SITE DEVELOPMENT PLANS

33 TOWNHOUSE UNITS

1525 & 1601 & 1603 & 1605 EAST 86TH STREET & 1604 & 1606 EAST 87TH STREET
BLOOMINGTON, MINNESOTA

REVISIONS	
04.28.26	CITY COMMENTS
05.12.26	REVISIONS
06.01.26	PLANS FINALIZED

UTILITY PLAN - SOUTH

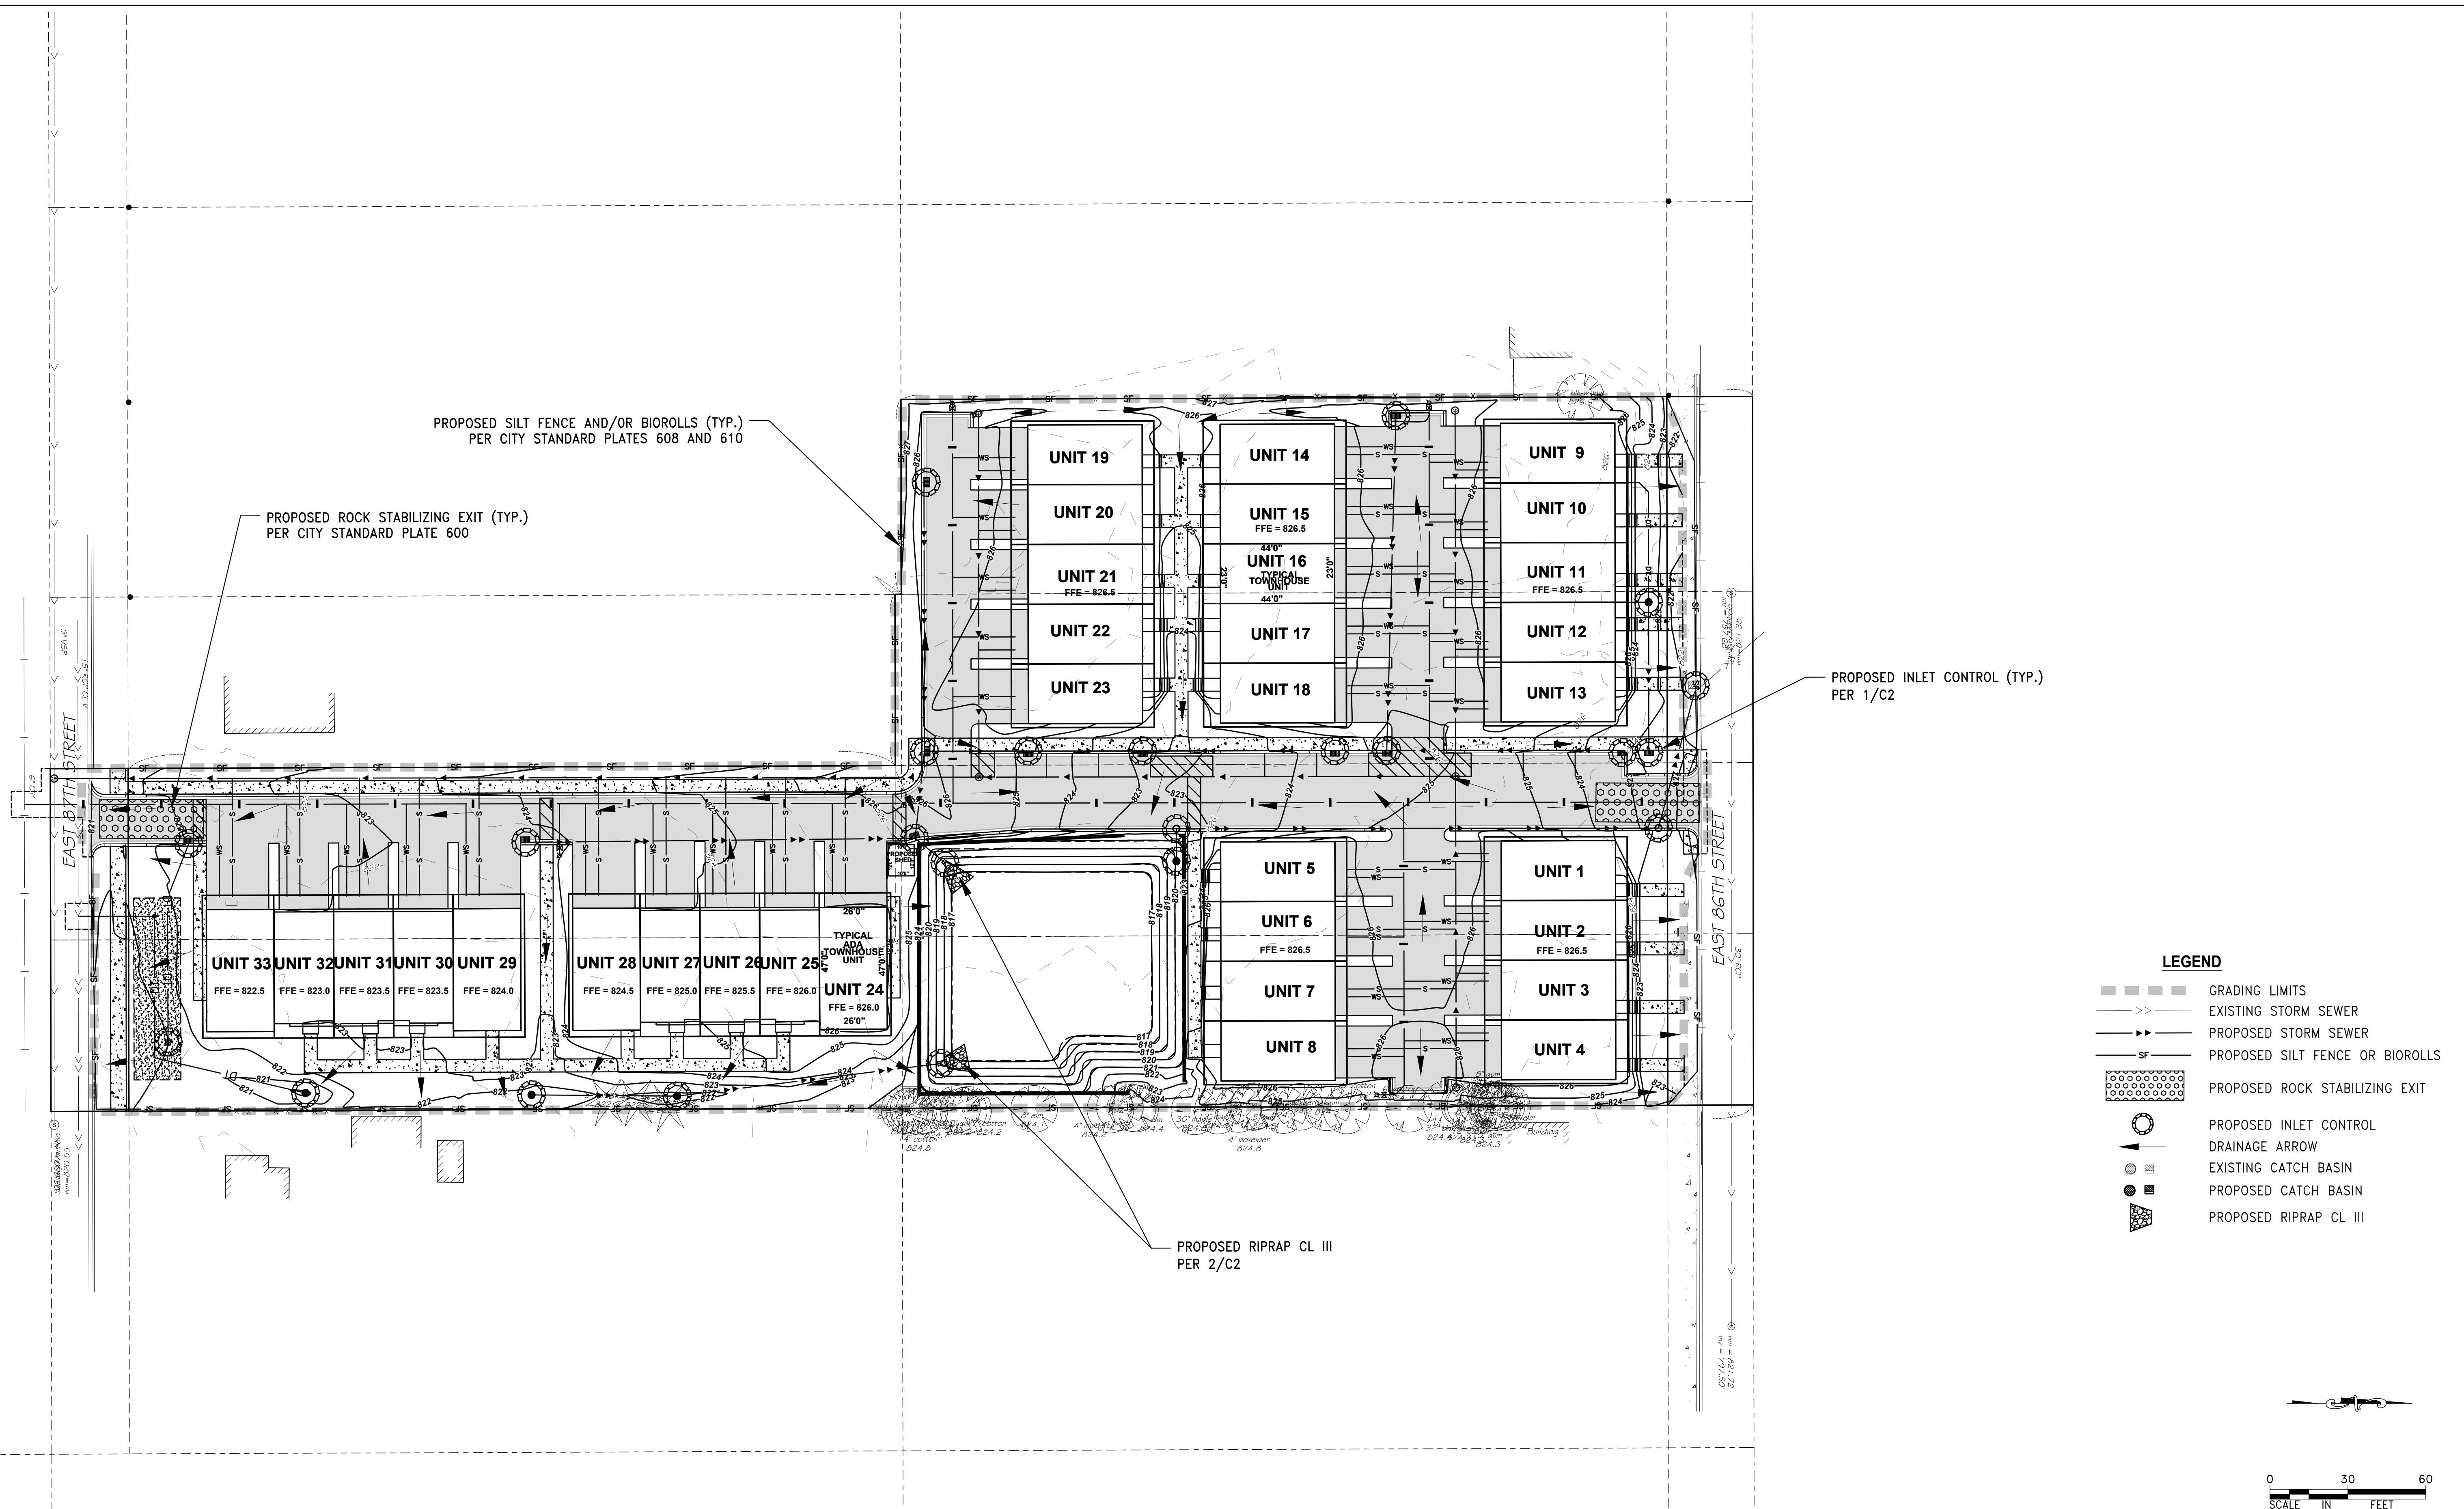
Confirm maintenance access route(s) for stormwater BMPs and pre-treatment devices & that access routes can support maintenance equipment space requirements & loads

Provide pre-treatment of all influent flows to stormwater BMPs in conformance w/ MPCA Stormwater Manual

Revise to connect to catch basin or manhole. Either core-drill into existing structure or install a new structure at connection.

Utilities review: Verify water has 18" minimum separation from any storm/sanitary.

Utilities review: Taps of live water mains are done by City forces. The Contractor pays for and coordinates this work. - add this note to the plan.

Utilities review: Use zinc coated Class 52 DIP water main. A minimum 8 mil V-Bio encasement is required on all DIP. - add this note to the plan

Consider use of surface basin instead of french drain to allow more efficient maintenance and better manage larger event flows

STORMWATER POLLUTION
 PREVENTION PLAN NOTES

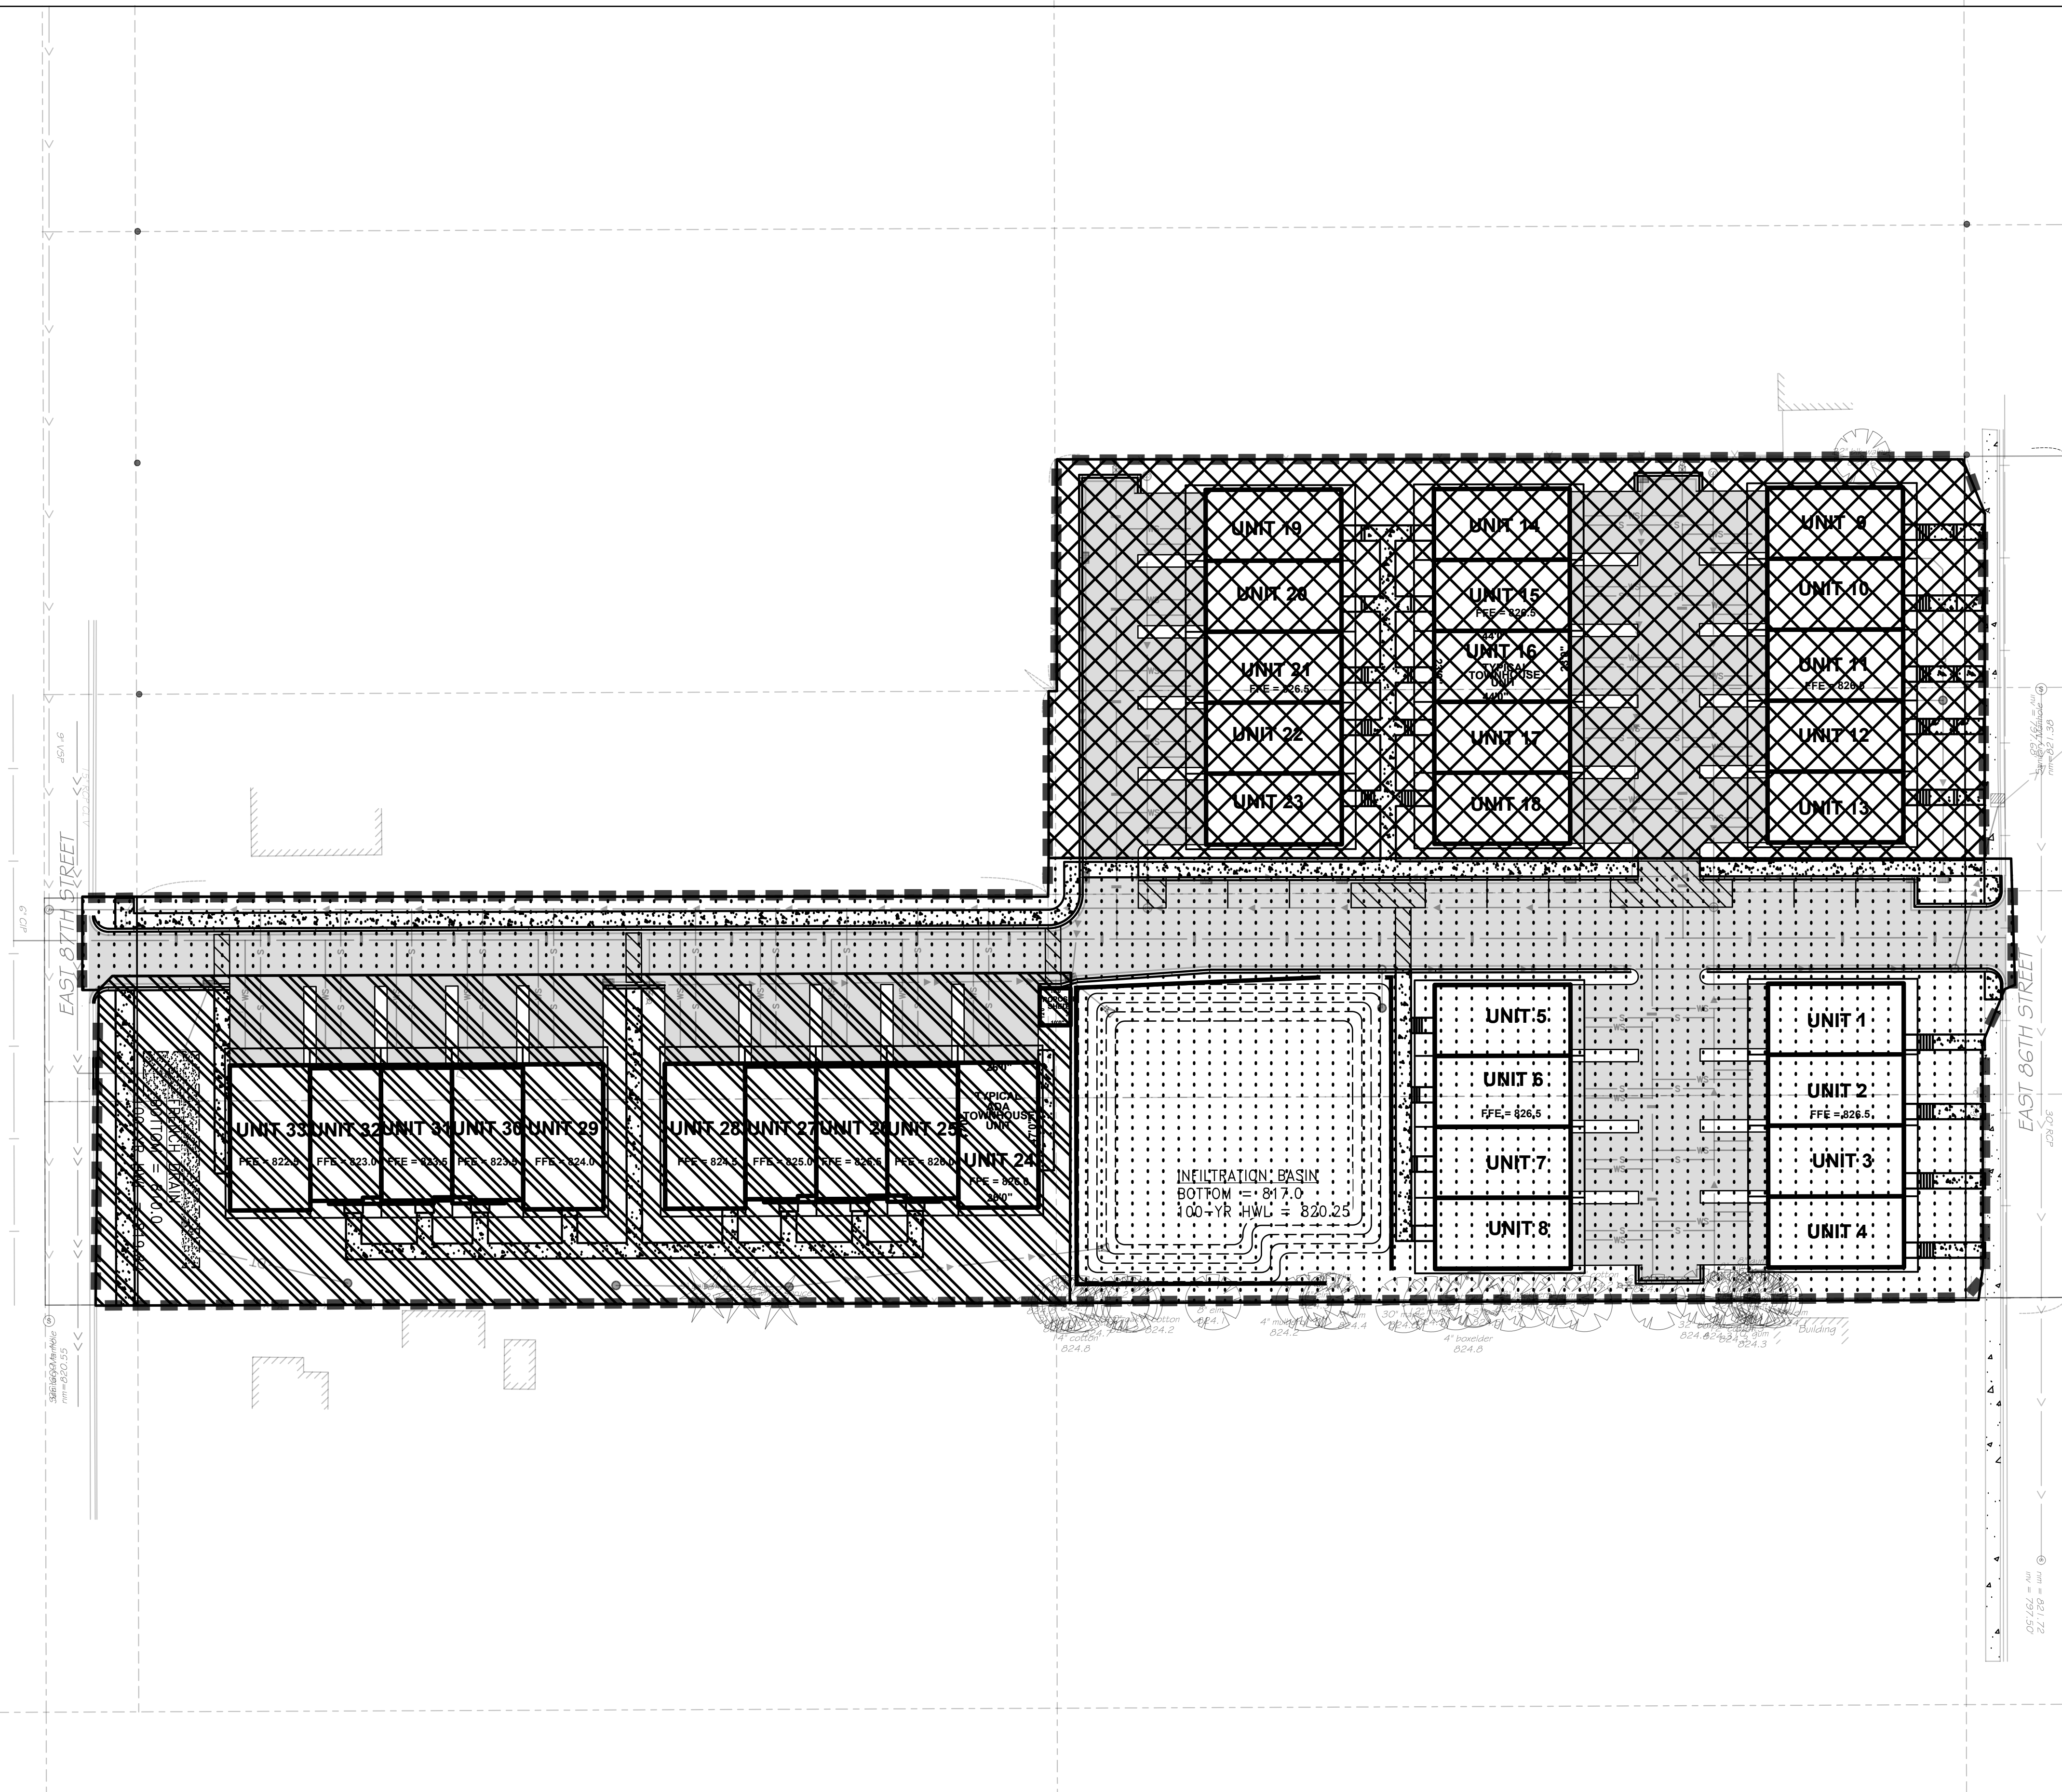
Include documentation describing how the infiltration basin's infiltration capacity will be protected throughout construction, given that its construction is shown as Phase 1 and the rest of the site will continue to be worked.

LANDSCAPE PLAN

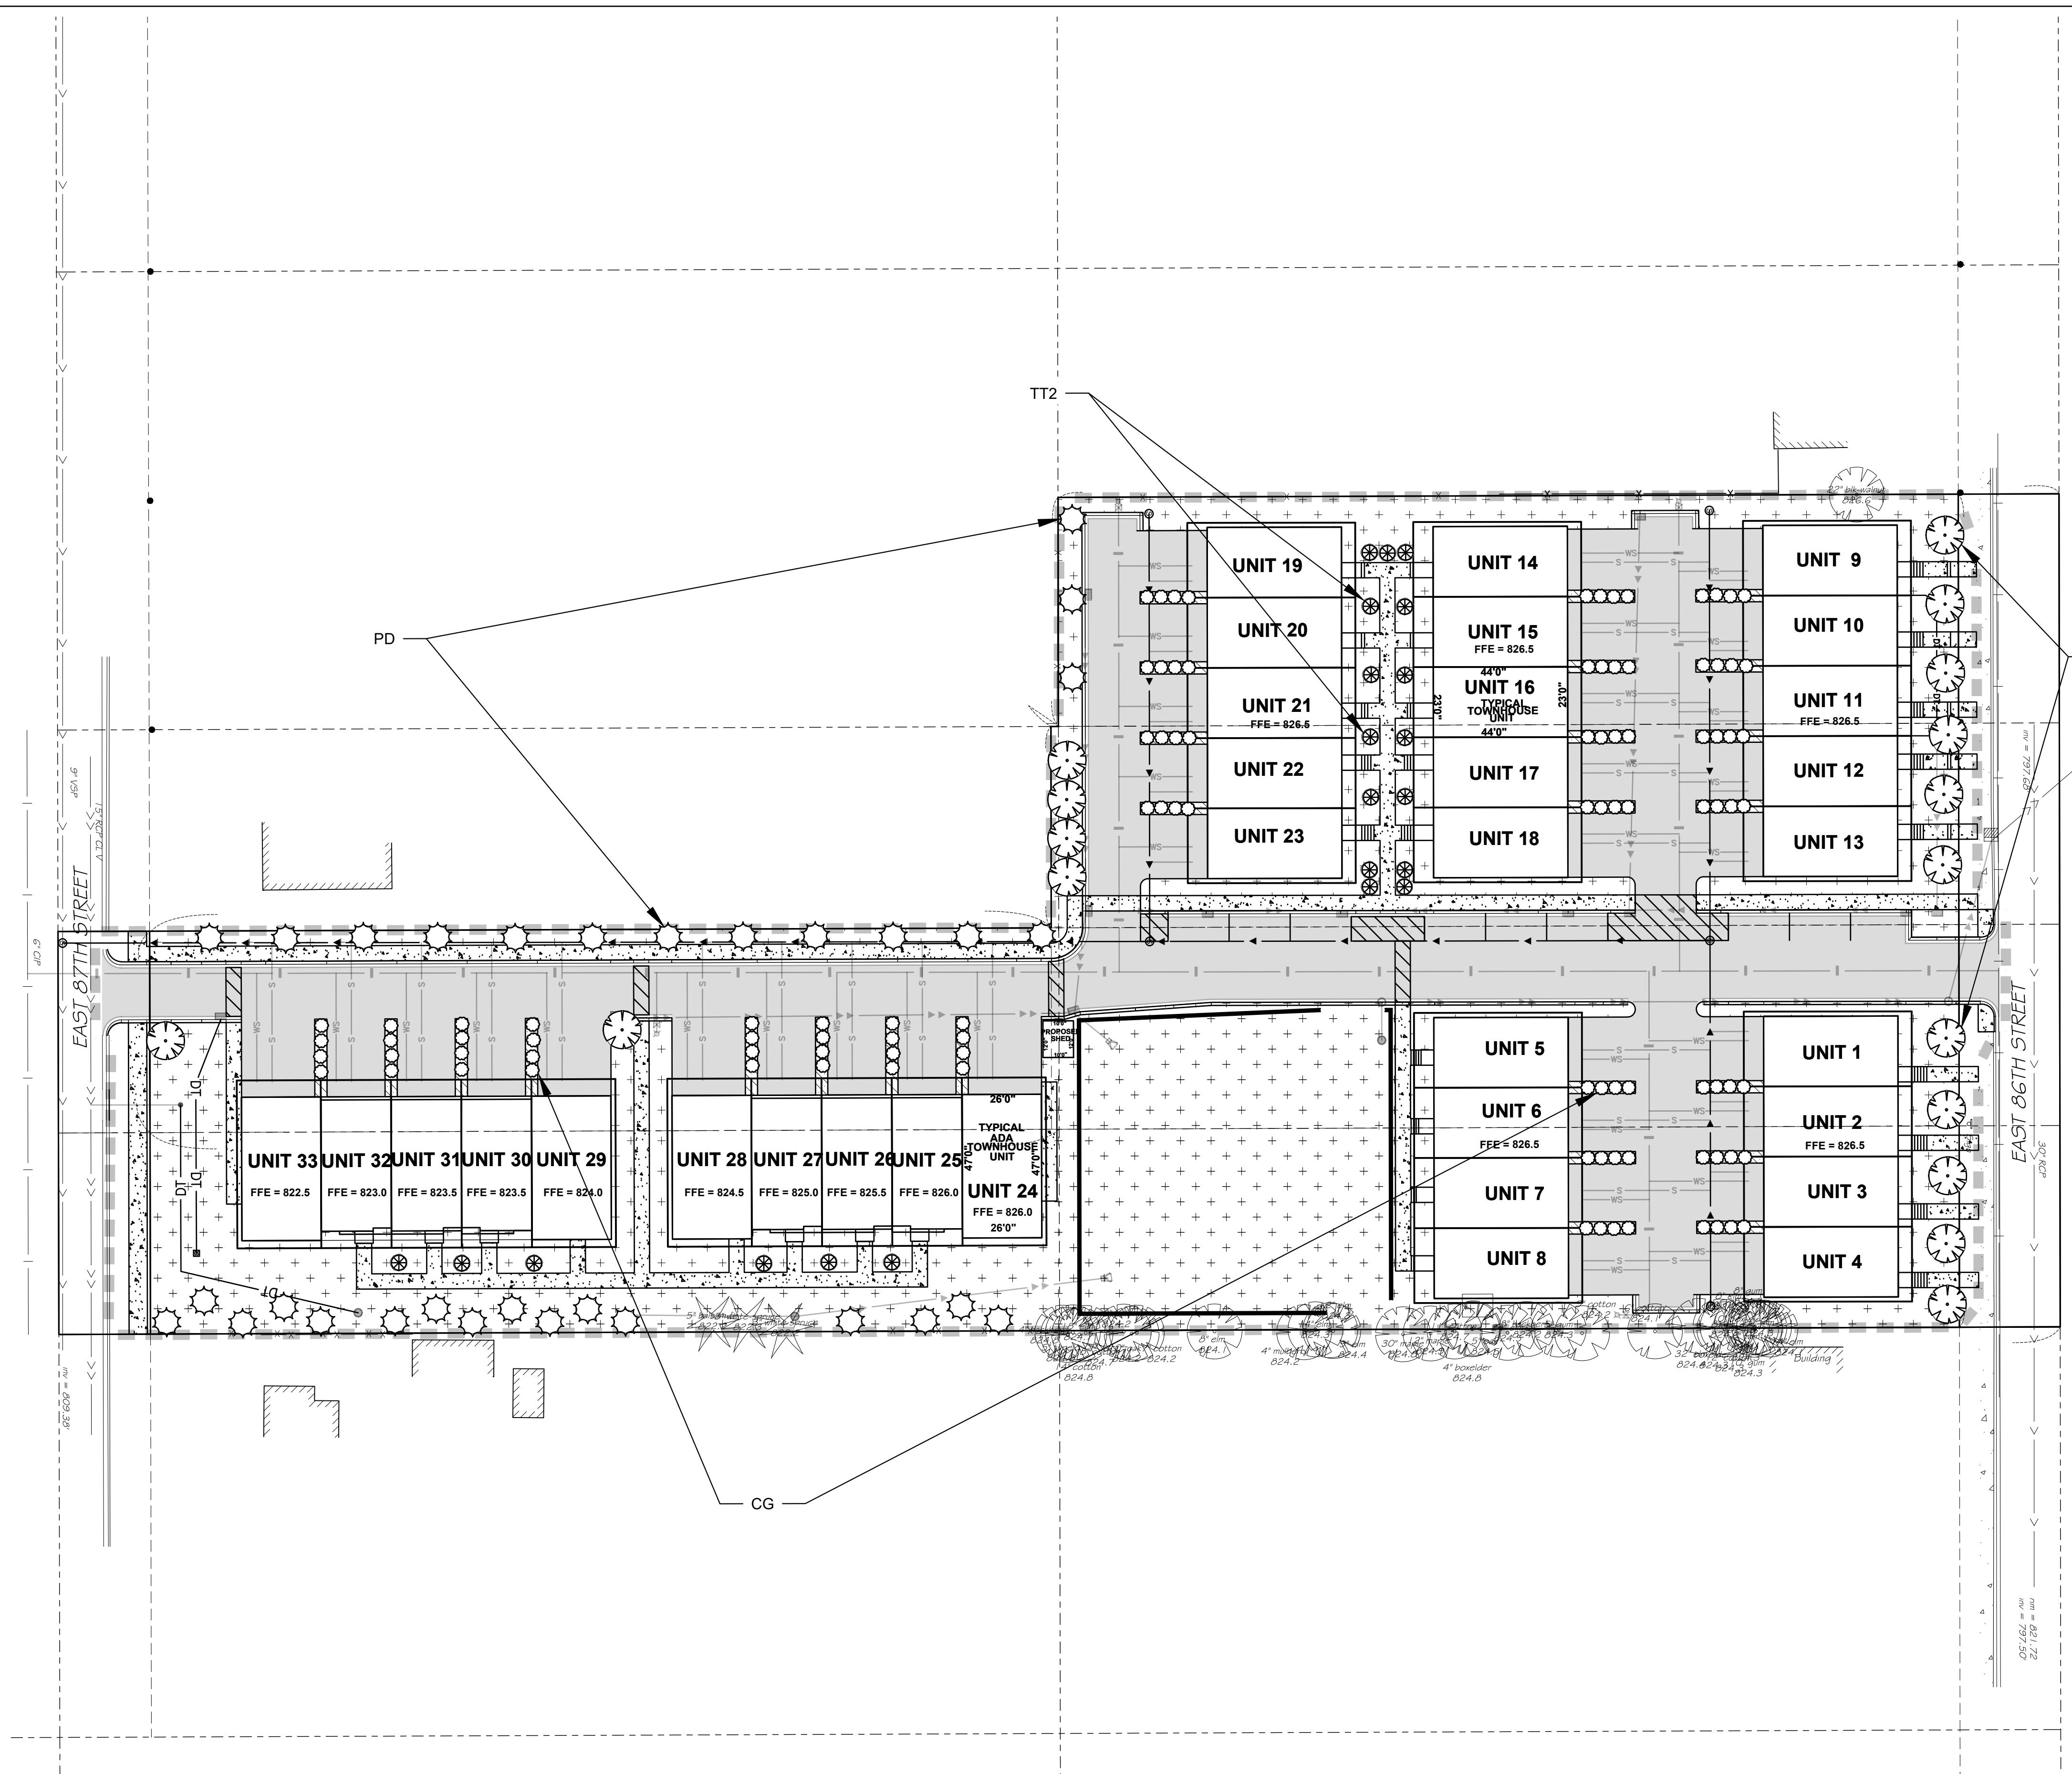
Landscape surety is required for the plant material.
